**ZONING AMENDMENT,
PLANNED UNIT DEVELOPMENT &
SUBDIVISION STAFF REPORT**

Date: September 1, 2011

Midtown Mobile Subdivision

SITE PLAN

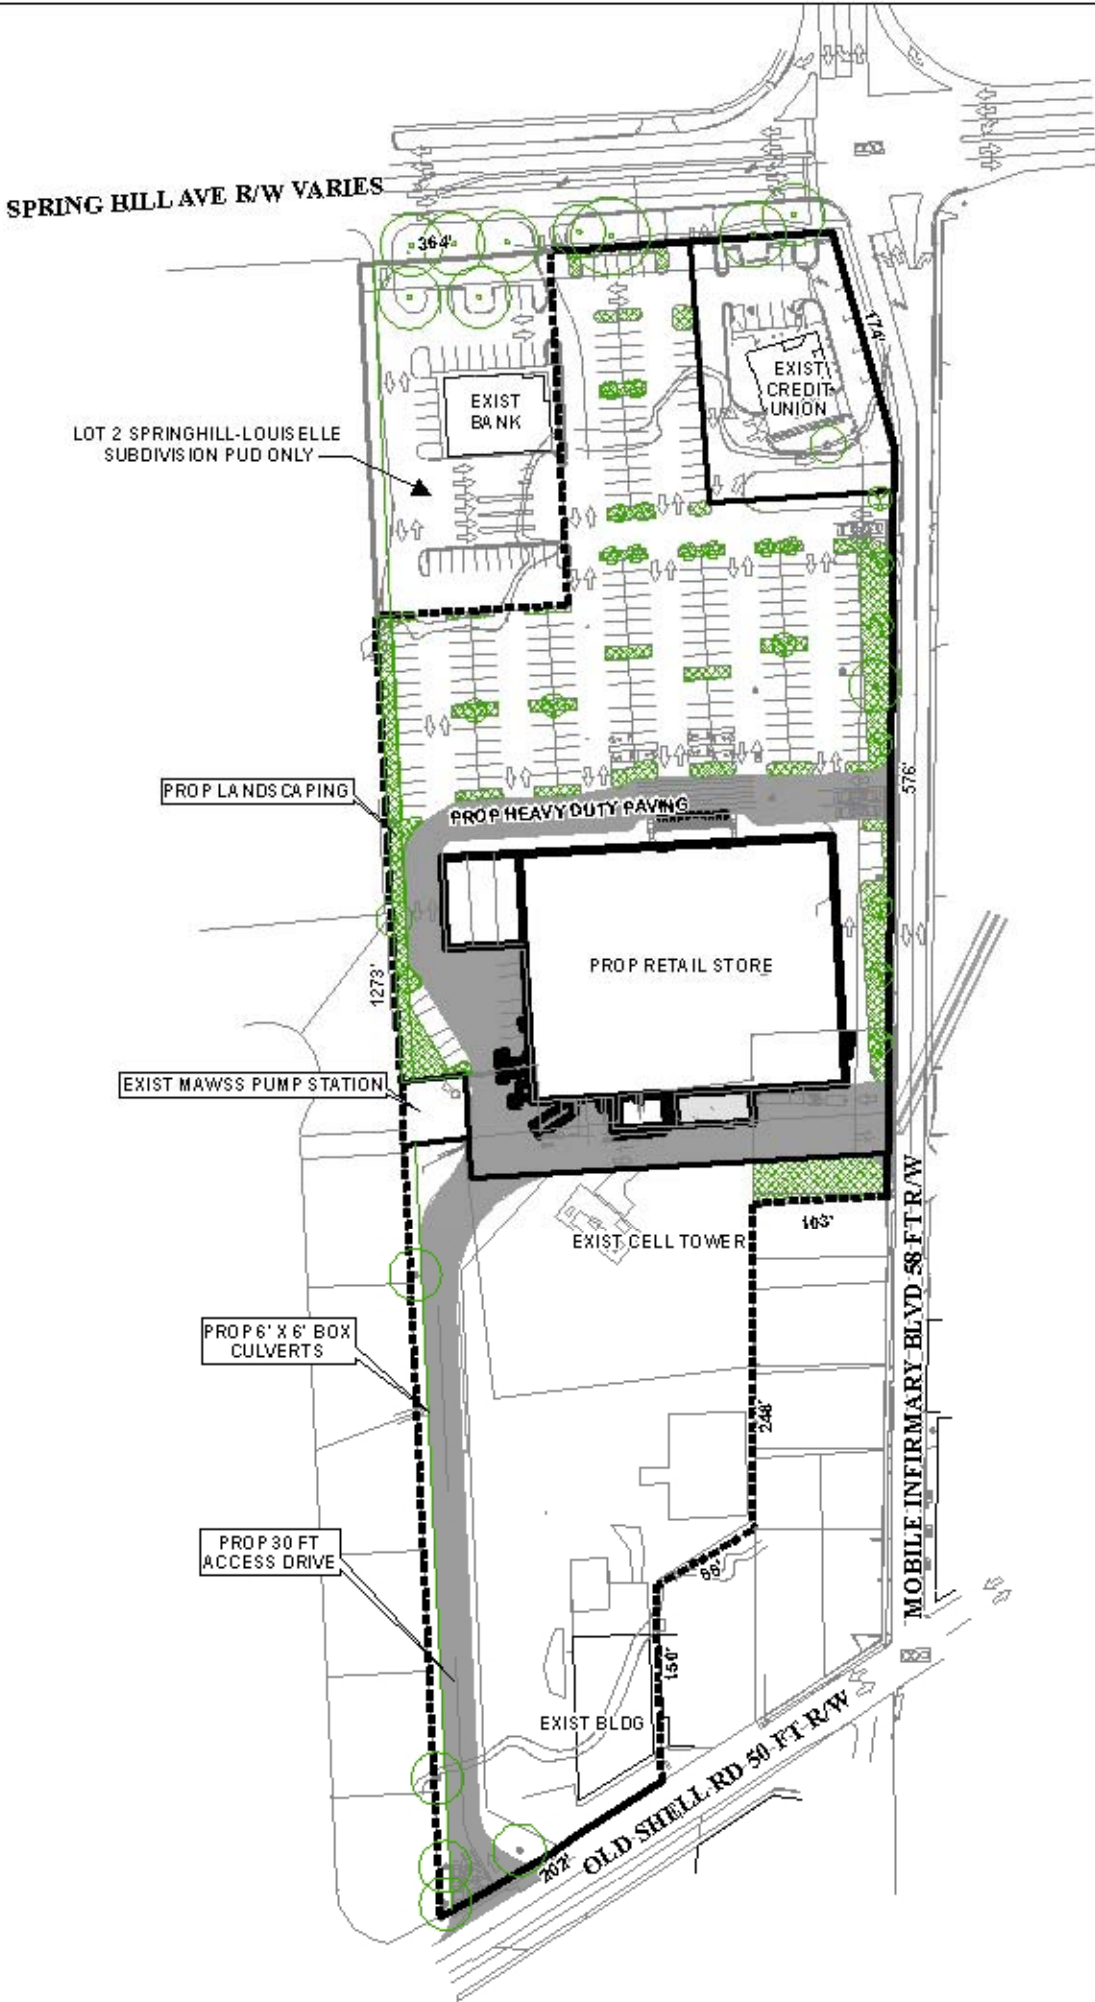
Driveway number, size, location, and design to be approved by Traffic Engineering and ALDOT and conform to AASHTO standards. A Traffic Impact Study will be required for this development and the developer will be responsible for performing the recommendations. The eastern most driveway on Springhill Avenue should be redesigned to avoid conflicts with the landscape island and bank traffic.

Preservation status is to be given to the 50" Live Oak Tree located on the West side of Lot 2. Any work on or under this tree is to be permitted and coordinated with Urban Forestry; removal to be permitted only in the case of disease or impending danger.

Coordinate with Urban Forestry location and design of the proposed driveway to Old Shell Road in order to minimize impact to the root systems of existing Live Oak Trees.

Coordinate with Urban Forestry location and design of the access, maneuvering, and parking along Spring Hill Avenue to minimize the impact to the root system of the 50" Live Oak Tree on Spring Hill Avenue right of way that is not shown on the site plan.

The site plan indicates approximately 245 parking spaces provided on Lot 2; however, no information is provided regarding the landscaping percentages or the location of the required trees. As the Planned Unit Development is proposed with several common interior property lines, staff has in the past allowed these interior property lines not be counted as perimeter lot lines, but rather look at the overall Planned Unit Development (PUD). Detailed information must be provided so that staff can determine if the site meets tree and landscape requirements. Also, buffer requirements as per Section 64-4.D.1. and the location of all dumpsters with screening illustrated on the site plan.

The proposed lots, as depicted, meet the minimum size and street frontage requirements as regulated by Section V.D.2. of the Subdivision Regulations. The areas of the lots are not depicted in square feet, and the 25-foot minimum building setback lines are also not depicted, and these notations should be included on the Final Plat, if approved.

- 1) revision of the site plan to show **ALL** improvements on the site including, but not limited to: recommendations of the Traffic Impact Study;
- 2) compliance with Urban Forestry comments “Preservation status is to be given to the 50” Live Oak Tree located on the West side of Lot 2. Any work on or under this tree is to be permitted and coordinated with Urban Forestry; removal to be permitted only in the case of disease or impending danger. Coordinate with Urban Forestry location and design of the proposed driveway to Old Shell Road in order to minimize impact to the root systems of existing Live Oak Trees. Coordinate with Urban Forestry location and design of the access, maneuvering, and parking along Spring Hill Avenue to minimizes the impact to the root system of the 50” Live Oak Tree on Spring Hill Avenue right of way that is not shown on the site plan”; and
